LOUISIANA UNIFORM PUBLIC WORK BID FORM (ADDENDUM 02)

BID FOR: Lift Station 21 Relocation
Mandeville, LA

Section 2- Plans:

Section 4- Questions received prior to, during and after Pre-bid meeting:

FINISHED SANITARY FLOW SCHEMATIC
N.T.S.

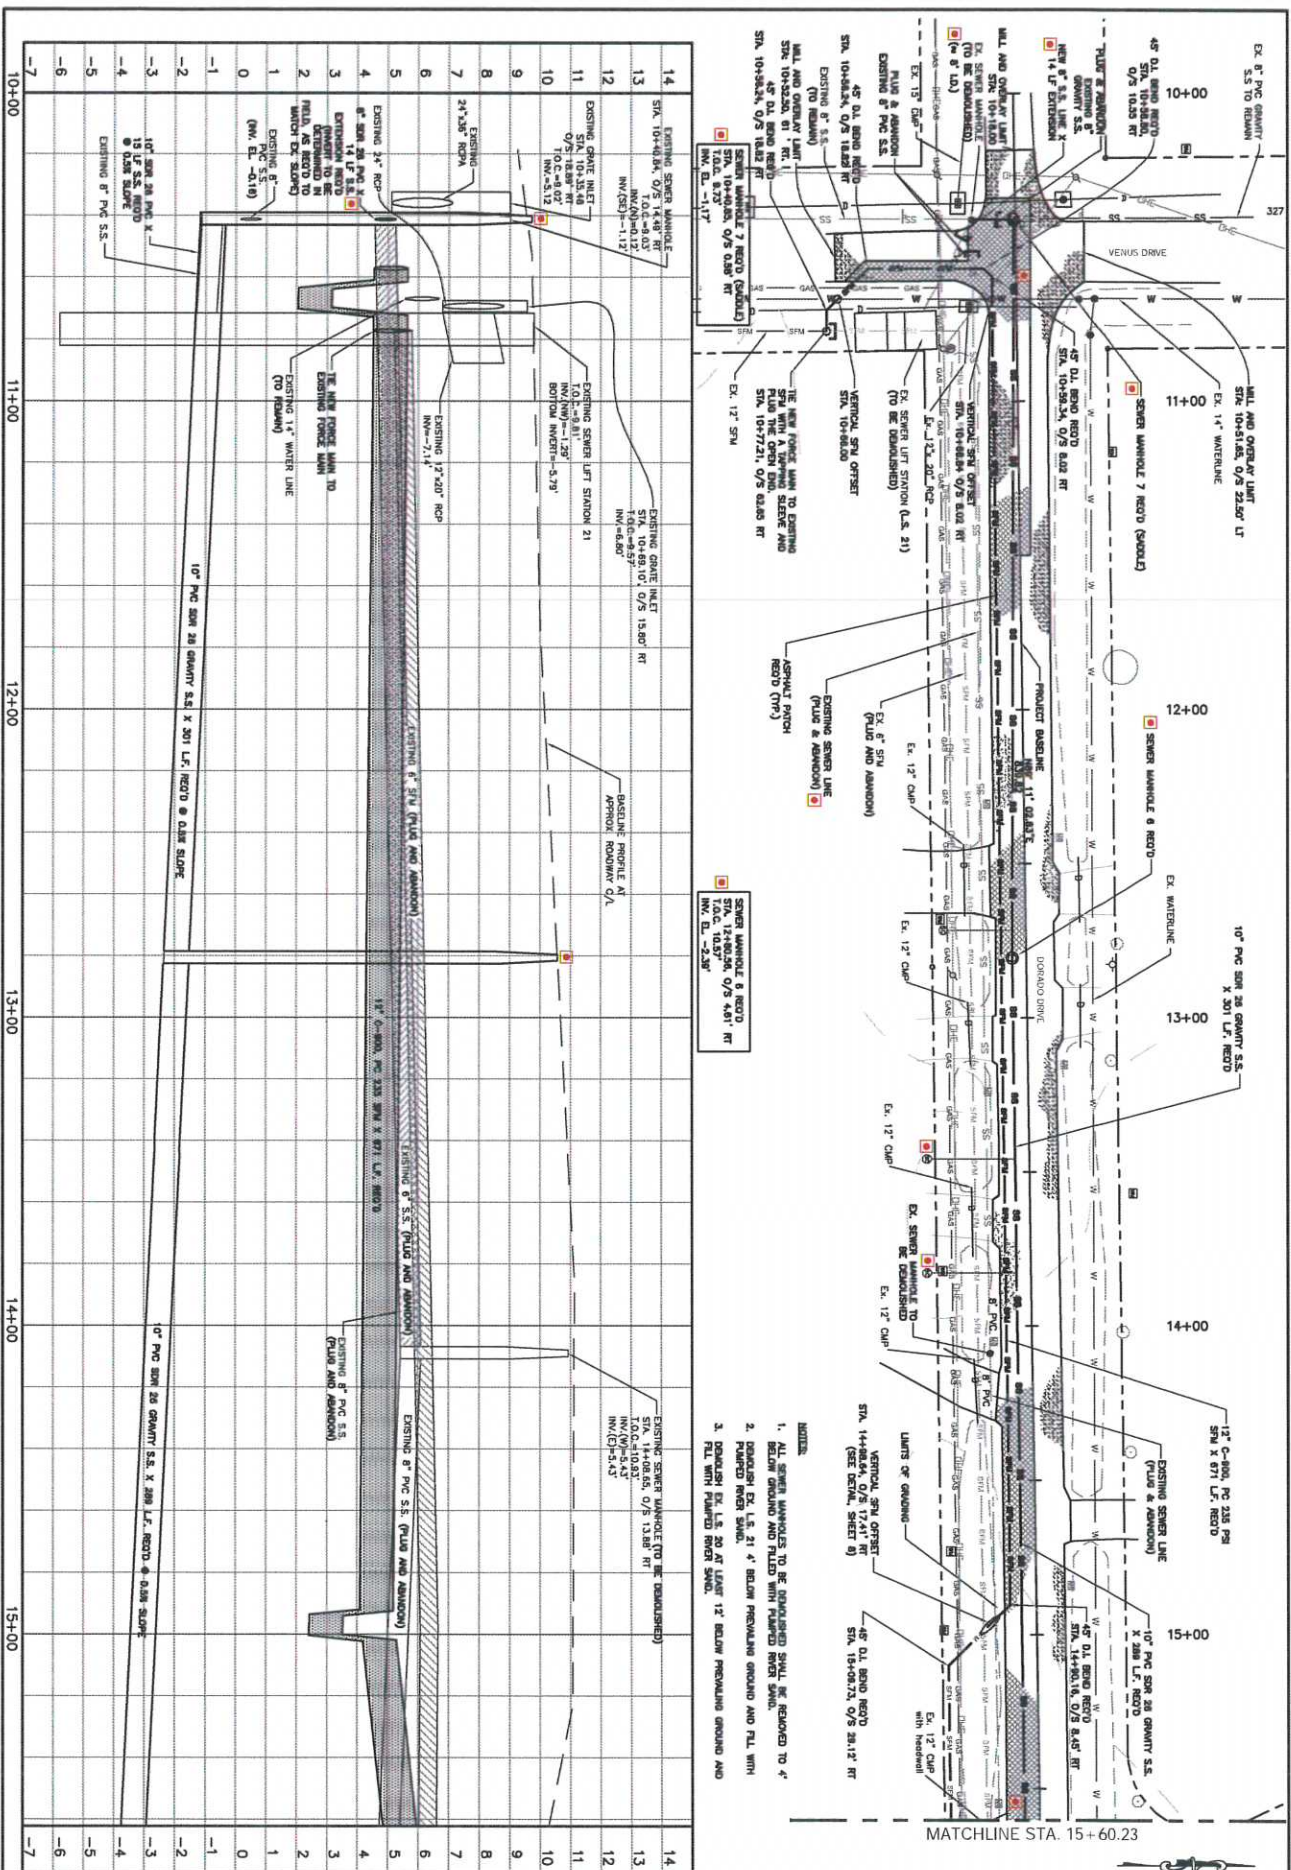
- 
- Delete Sheet 3 and replace with the attached Sheet 3.
 - Delete Sheets 6 and 7 and replace with the attached Sheets 6 and 7.
 - Sheet 9 of 25, "Project Details" on Trench and Bedding Notes, Change last sentence of Note 1 reading "Timber Sheeting when used, shall be cut off to a minimum of 3' below grade and left in place" to read **"Sheeting (Steel or Timber) is not required to be left in place."**
 - Sheet 25 of 25, Air bell details shown on this sheet is out of section and is symbolic representation only. The location of the guide pipe for the air bell shall be as shown on Sheet 11 of 25 and shall be securely clamped to discharge piping utilizing 316 S.S. straps as specified in the detail.
